SUBJECT: Recent Board Visit and Transmit Issue 3a

Enclosure:
Seismic Issue Resolution-Issue 3a

Issue No. Response Revision No. Date of Identified Date of Response **Description of Issue:**Comparison Of The SRS And USGS Hard Rock Spectra

Figure 1
USGS 2 Hertz HAZARD CURVE AT SRS

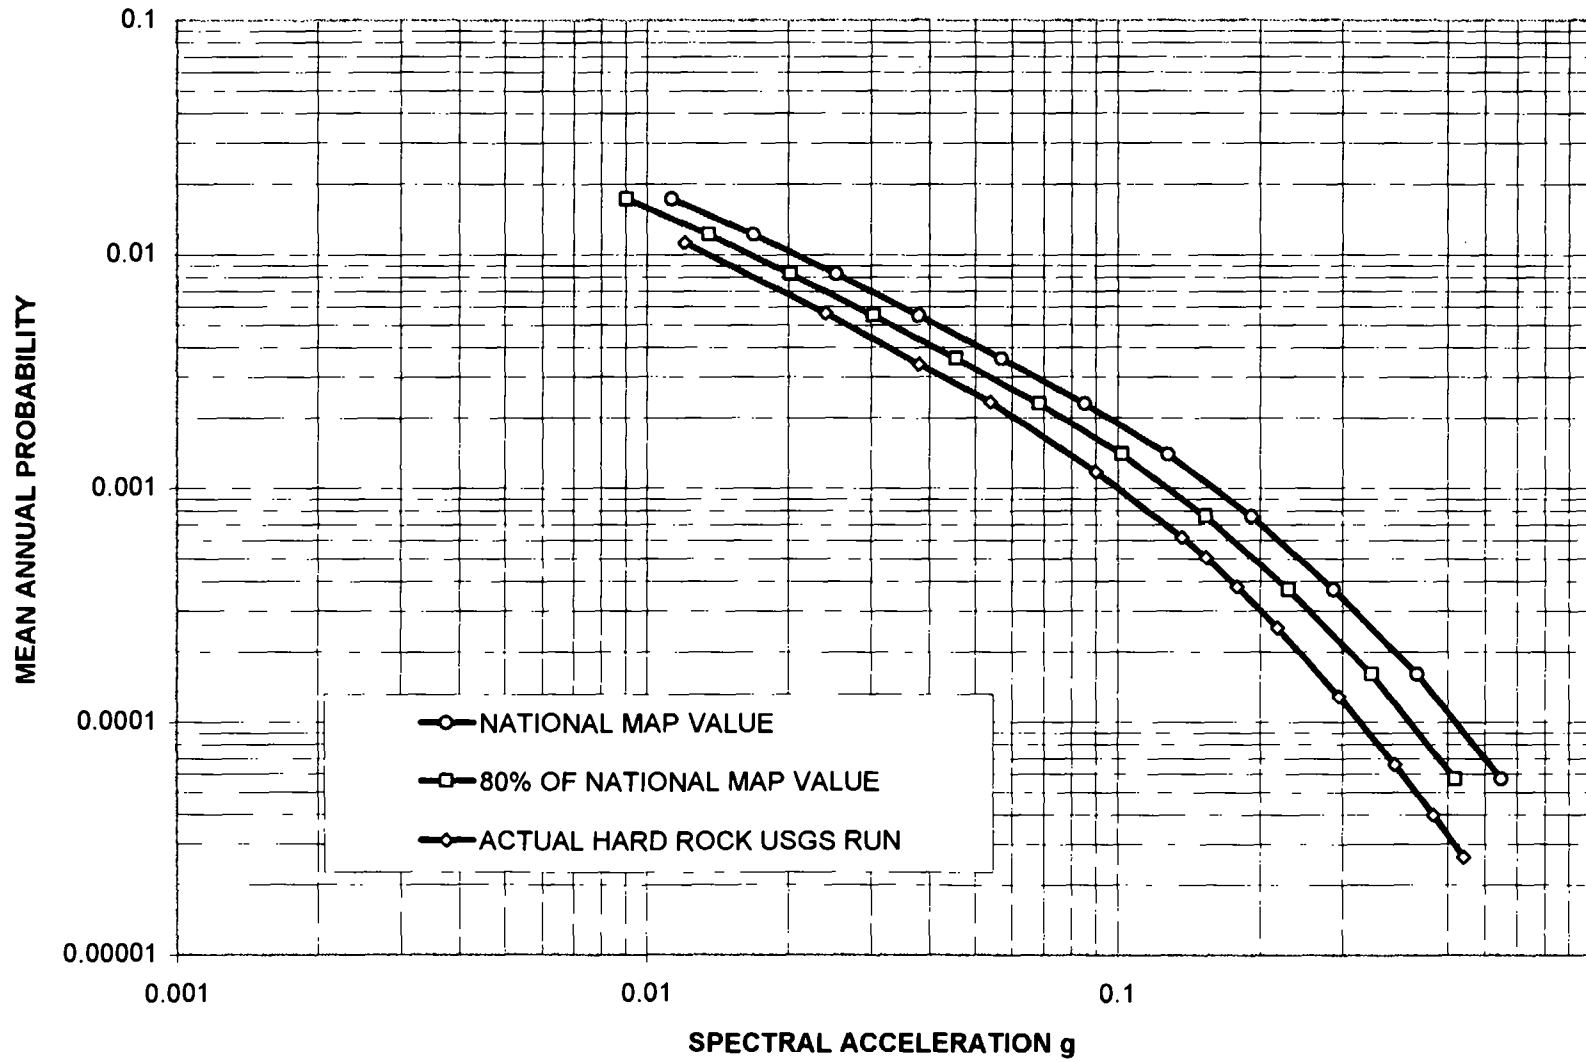
Explain, in terms of the seismologic/geologic considerations, why there are significant differences in the recommended NEHRP and SRS PC3 rock spectra, both in frequency content and amplitude.

Figure 1 compares the 2-Hz seismic hazard curves from the National Map, a seismic hazard curve derived from the National Map for hard-rock (labeled 80% of National Map value which follows NEHRP97 site response factor for hard-rock), and the actual hard-rock hazard curve provided by the USGS (weighted average of 3 attenuation models as described above). Figure 1 clearly illustrates that the National Map derived hard-rock curve (80% curve) provides an overconservative estimate of seismic hazard for hard-rock site conditions at SRS. This is particularly important when hard-rock seismic hazard is used as input into quantification of site response. In other words, it is not correct to use as input seismic hazard curves derived from the National Map, adjusted for "hard-rock" based on NEHRP97.
